## LUFTDYKTIGHETSPÅBUD (LDP)

MOONEY - 1

### 92-044 KONTROLL AV SIDERORETS STATISKE BALANSE

### 96-009 KONTROLL AV «ALTERNATE AIR DOOR ASSEMBLY»

FIG.1

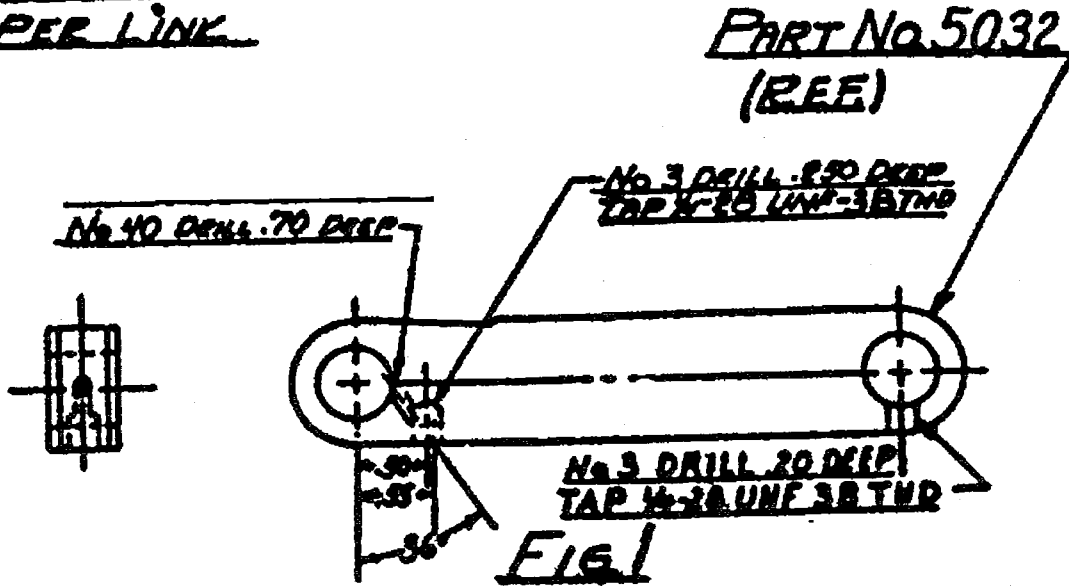
INSTALL MS15002-1  
GREASE FITTINGS 2 PLACES  
PER LINK

For M20 and M20A models the present retract links are to be modified by the addition of grease fittings as shown in Figures 1 and 2 attached. Follow procedures in Mooney M20/M20A Service and Maintenance Manual or other FAA approved procedure, for removal and replacement of links. Service Bulletins, Service Letters and Service Instructions referenced in this AD may be obtained from Mooney Aircraft, Louis Schreiner Field, Kerrville, Texas.
